BenFab, Inc.
13 S. Highland Ave Lansdowne, PA 19050
Phone: 610-626-9100 Fax: 610-626-9200
www.benfabrailings.com

Sullivan Triad Building
200 Renaissance Blvd
King of Prussia, PA

AMC Georgetown
TYPICAL SHOP
DRAWINGS

ELEVATOR
SECTION A-A

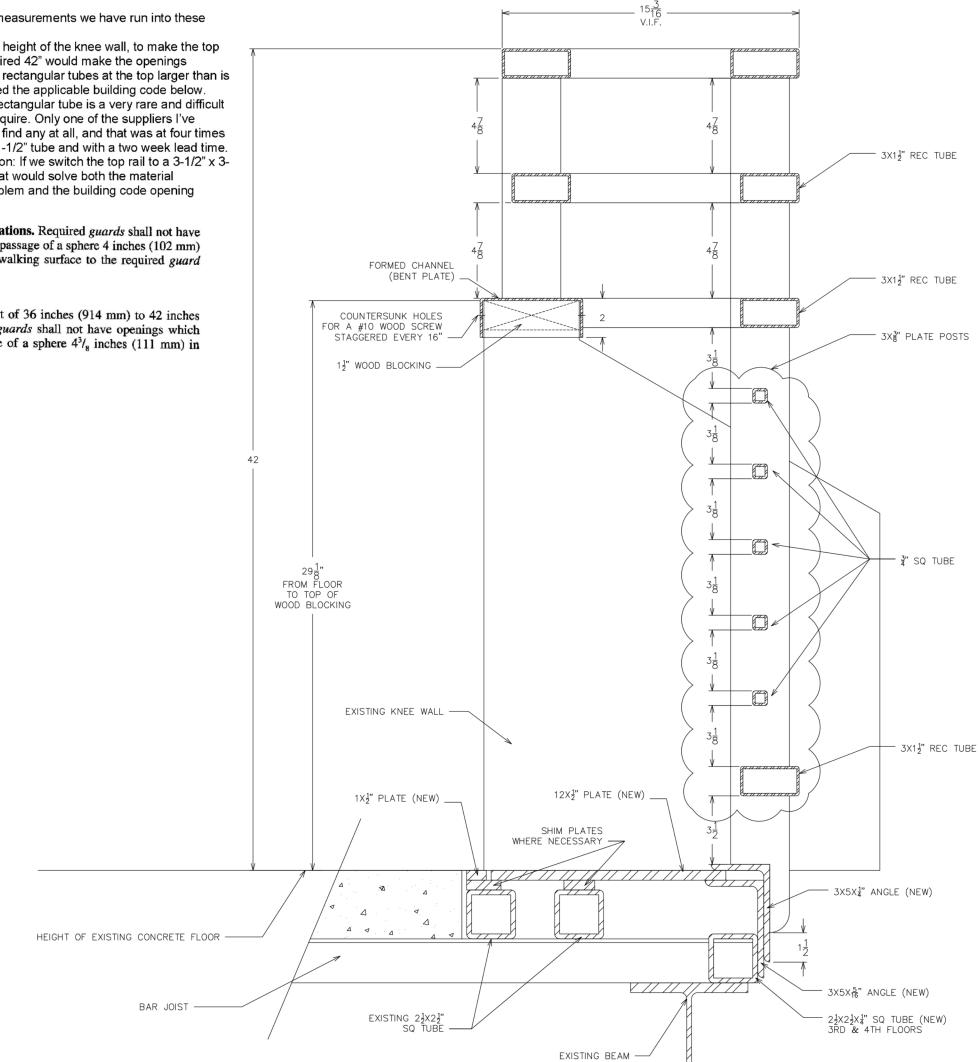
After taking our field measurements we have run into these possible issues:

- 1) Due to the current height of the knee wall, to make the top of the rail the required 42" would make the openings between the three rectangular tubes at the top larger than is allowed. I've quoted the applicable building code below.
 - 2) A 3-1/2" x 1-1/2" rectangular tube is a very rare and difficult size material to acquire. Only one of the suppliers I've called was able to find any at all, and that was at four times the price of a 3 x 1-1/2" tube and with a two week lead time.
- a) Possible solution: If we switch the top rail to a 3-1/2" x 3-1/2" sq tube that would solve both the material availability problem and the building code opening limitations.

1013.4 Opening limitations. Required guards shall not have openings which allow passage of a sphere 4 inches (102 mm) in diameter from the walking surface to the required guard height.

1. From a height of 36 inches (914 mm) to 42 inches (1067 mm), guards shall not have openings which allow passage of a sphere 4 1/4 inches (111 mm) in diameter.

OPTION 1:

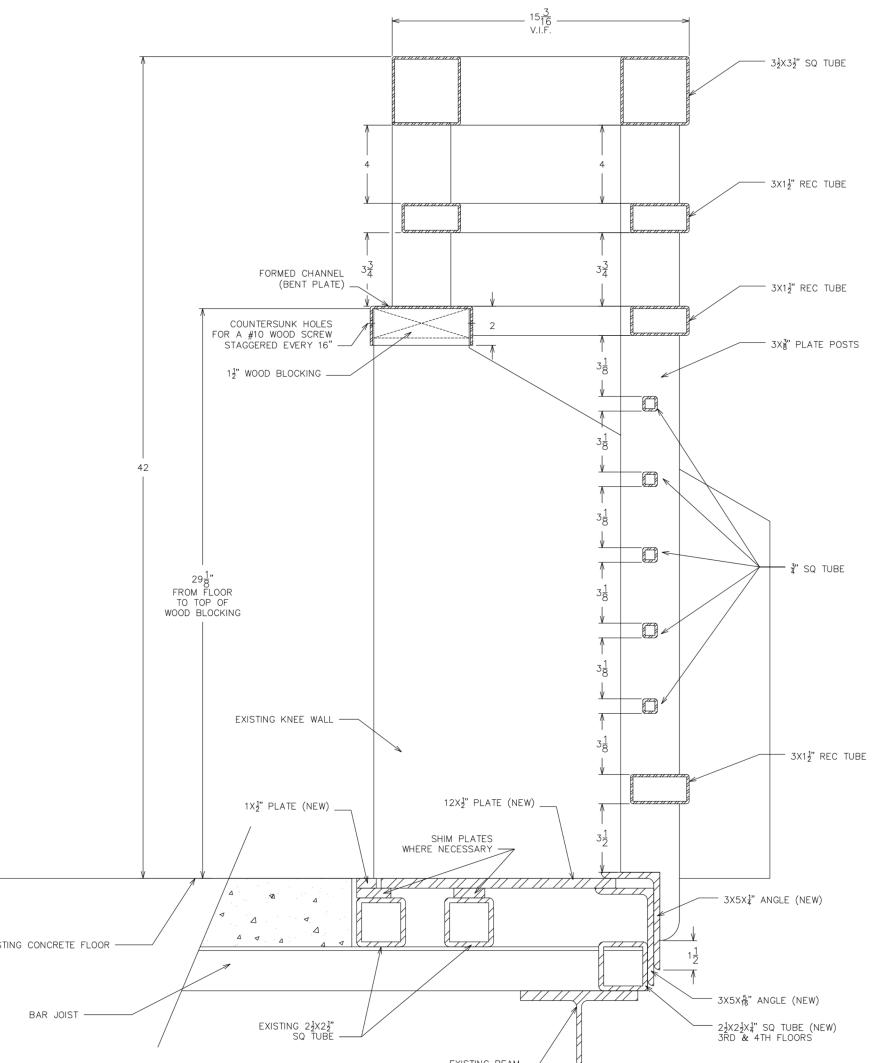
3½" X 3½" SQ TUBE TOP RAIL

OPTION 2:

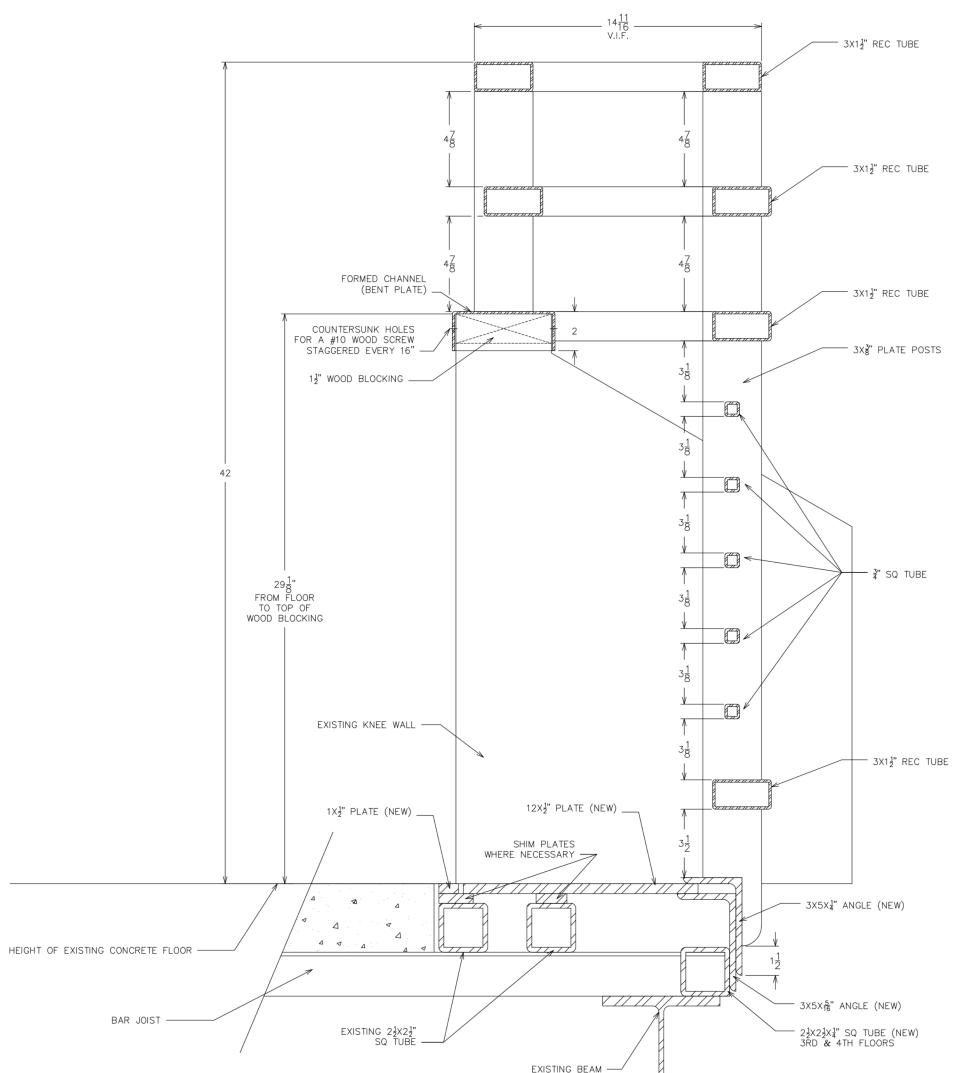
3 X 1 $\frac{1}{2}$ " REC TUBE TOP RAIL

OPTION 4:

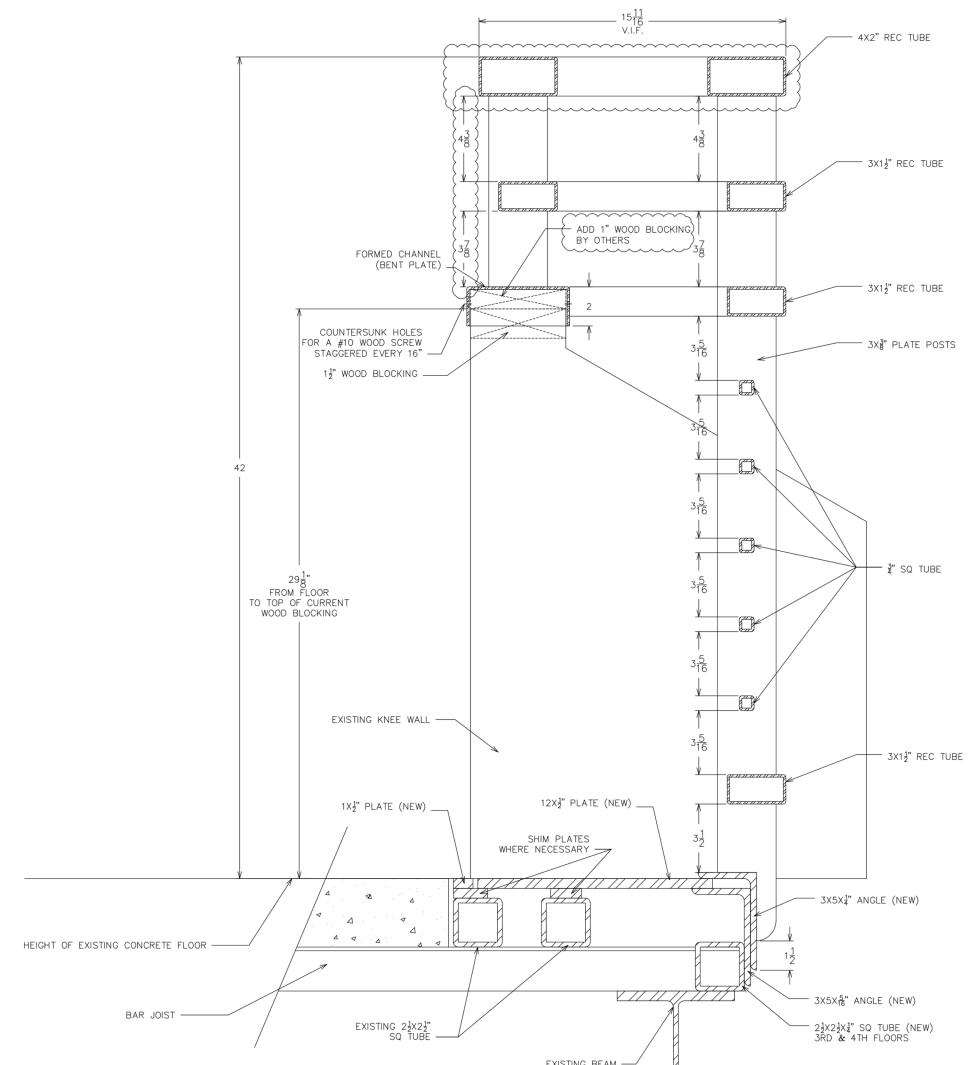
4 X 2" REC TUBE TOP RAIL (CENTERED)
ADD 1" WOOD BLOCKING TO RAISE
OVERALL KNEE WALL HEIGHT

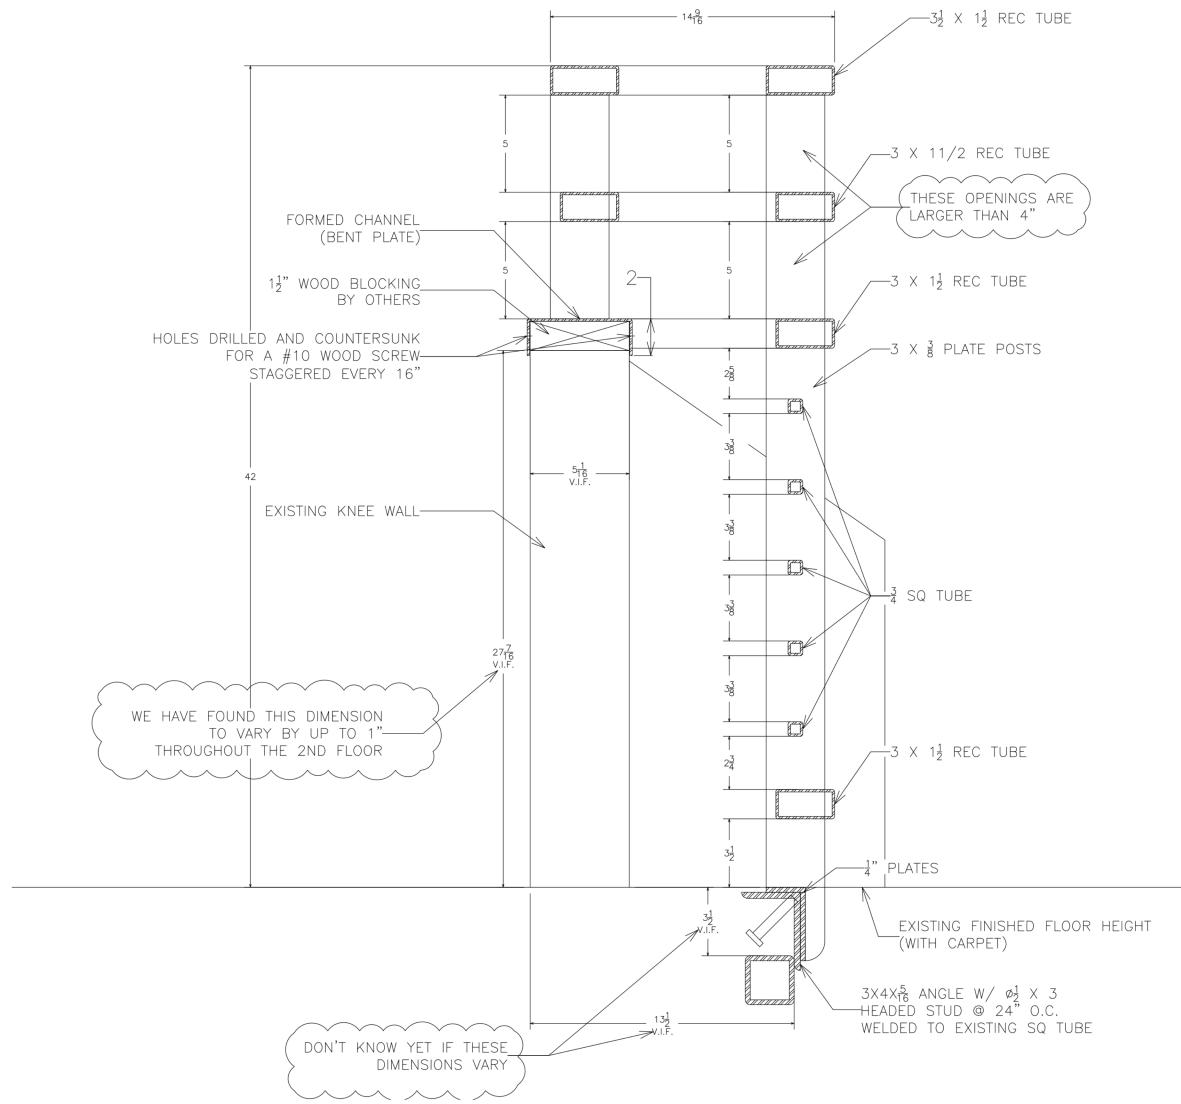
Our goal in the designing of these railings is to do so in such a way that we are building as few unique pieces as possible. After taking some preliminary measurements on the second floor we have run into these possible issues.

1. Due to the current height of the knee wall, to make the top of the rail the required 42" would make the openings between the three rectangular tubes at the top larger than 4"
 - a. If the openings where those tubes turn toward the bottom rail remain equal, they will also be larger than 4"
 2. Where we measured, throughout the second floor, we found a variation in the height of the knee wall of up to 1". This makes it difficult to keep the rails on top of the knee wall a consistent height with the guardrails at the knee wall openings.
 3. The location of the existing square tube to which we are to weld a $3 \times 4 \times 5/16$ " angle, may vary in both its horizontal and vertical placement. We won't know until they are all uncovered and measured.

POST MOUNTING DETAILS

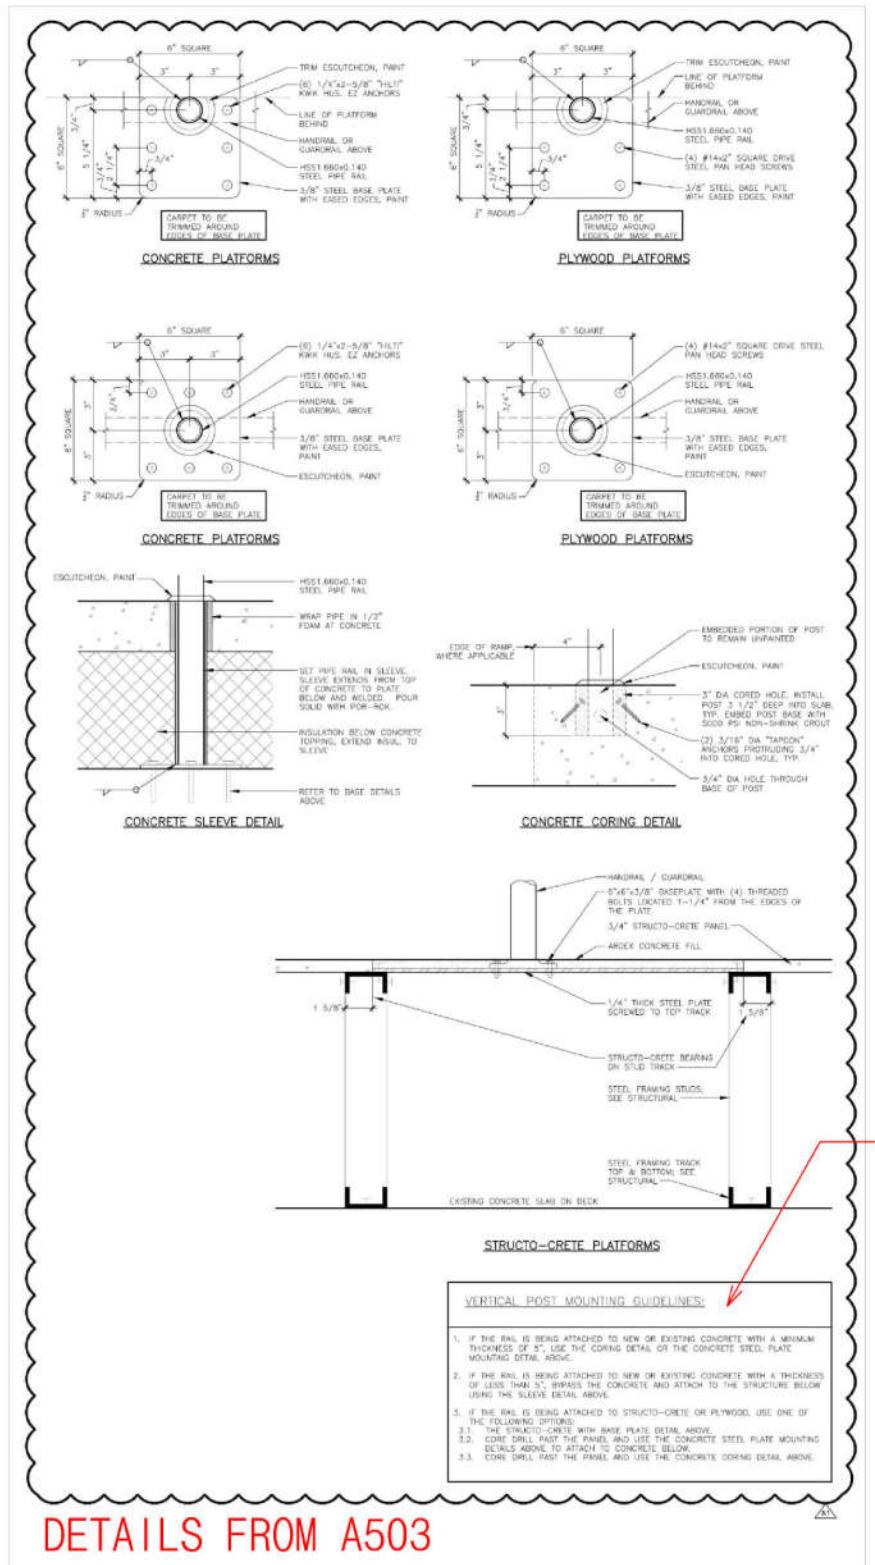
CABLE RAILING NOTES:
DETAIL 9 ON A503 CALLS FOR DIMENSIONS "A" AND "B" TO BE THE SAME. THIS DOESN'T WORK IF WE WANT TO KEEP THE CABLE SPACING LOOKING CONSISTENT. IN ORDER TO MAKE THAT WORK, DIMENSIONS "C" AND "D" MUST BE THE SAME.

DETAILS ON A502 ARE INCONSISTENT ABOUT WHETHER THE CABLE RAIL POSTS SHOULD BE MADE WITH SCH 40 OR SCH 80 PIPE. WE WOULD LIKE TO USE SCH 40 THROUGHOUT. IF WE USE SCH 80 FOR THE END POSTS, WHERE THE TOP RAIL MEETS THE END POSTS WILL NEED TO BE MITERED AND NOT BENT.
